49-51 BOLTON STREET

APPLICATION FOR PERMIT FOR HEATING, COOKING OR POWER EQUIPMENT

To Building Department 186-D-10
REPORT OF FIRE

Your application to rebuild deck has been reviewed and a permit is herewith issued subject to the following requirements:

49-51 BOLTON ST

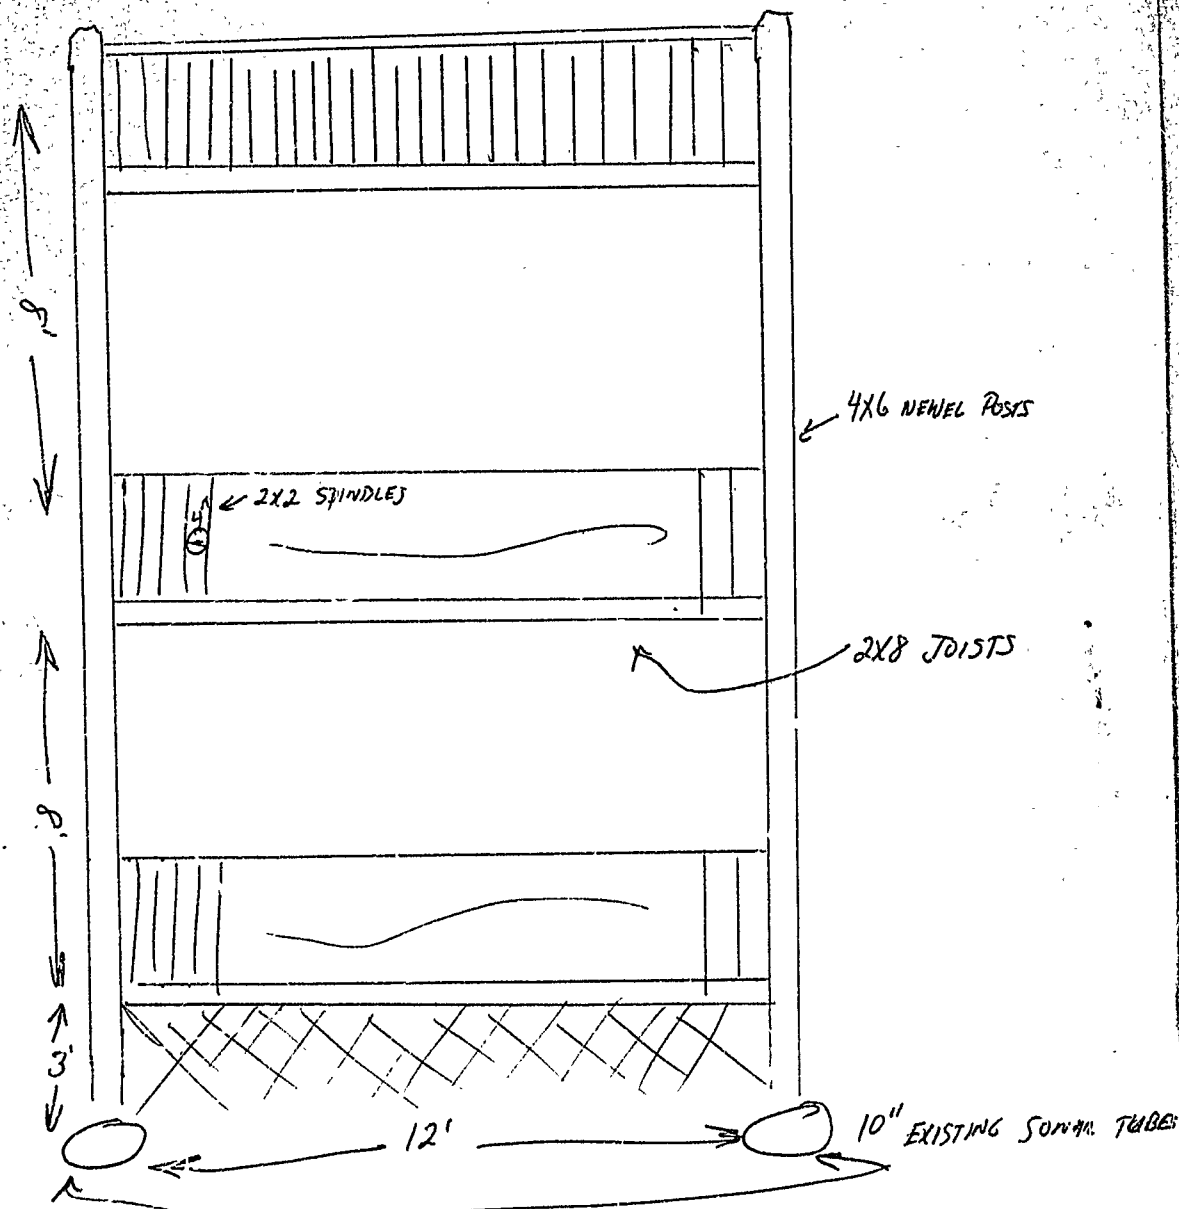
1. Guards and handrails shall comply with Section 5-2.2.4 of the Life Safety Code.
2. Stairs shall be in accordance with Section 5-2.2.2.1 of the Life Safety Code. (Maximum riser 7"-minimum tread 11")
3. Means of egress shall be illuminated.
